Planning Commission Staff Report

November 10, 2010
Item 6.c.

SUBJECT: PDR-933

PURPOSE: Application for Design Review approval to construct an approximately 3,972-square-foot two-story custom home with an attached two-car garage and an attached one-car garage.

Figure 3: First Floor Plan

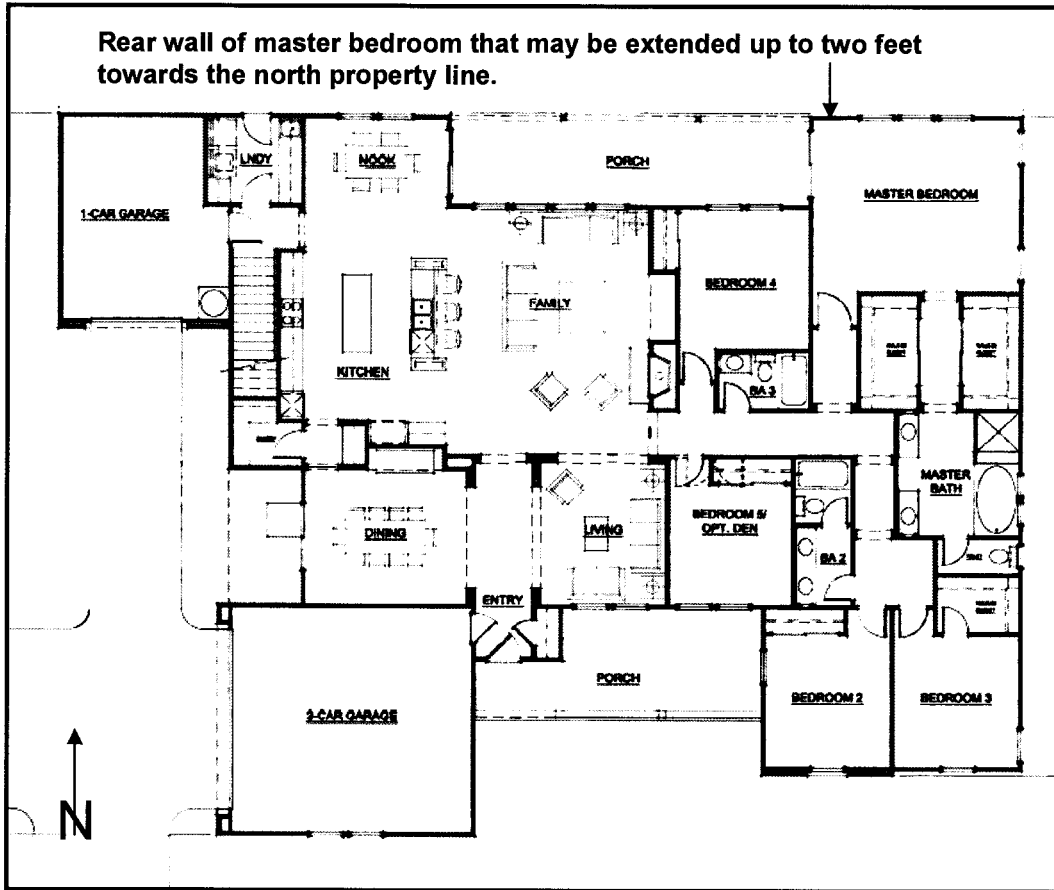
The applicant requests the ability to increase the depth of the master bedroom from one- to two-feet which will increase the building floor area from the 3,934 square feet stated on the design plans to 3,972 square feet and decrease the rear setback at the master bedroom from 40 feet to 38 feet. Figure 3, on the following page, is the proposed first floor plan for the home that shows the location of the master bedroom.

Figure 4: Left (West) and Right (East) Building Elevations

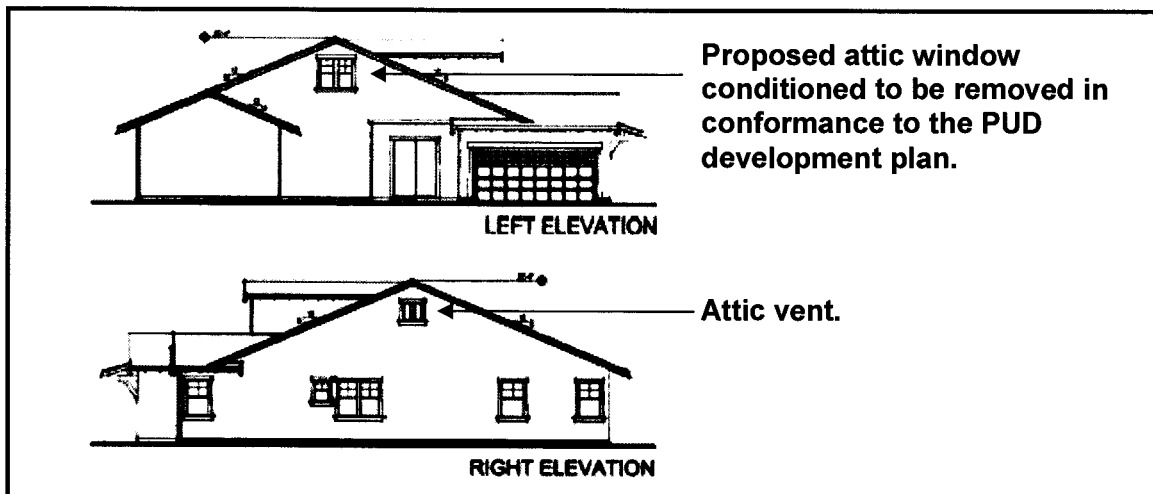
The proposed building conforms to the PUD development plan standards for height, floor area, setbacks, and window placement except for the attic windows shown on the west (left) building elevation. Figure 4, below, includes the proposed attic windows on the west (left) elevation and an attic vent on the east (right) elevation.

The applicant requests the two “ganged” windows on the west (left) building elevation, in addition to the window shown with the dormer, to provide natural light and air to the second floor/attic area for future living area including bedrooms. The PUD development plan, however, specifies that the second-floor/attic windows for this lot shall be designed only as dormers facing south, i.e., towards Yolanda Court. Therefore, as conditioned, staff recommends that the second floor/attic windows be removed from the west building elevation in order for the Planning Commission to be able to approve the proposal in compliance with the PUD development plan and design guidelines on this issue.

The applicant concurs with the staff recommendation in order to move the application forward, and will be submitting a modification of the PUD development plan to modify this requirement in order to add the windows to the west building elevation and possibly to the east building elevation. As conditioned, the design review application does not require the development plan modification. The applicant intends to address the Planning Commission at the public hearing on this issue.
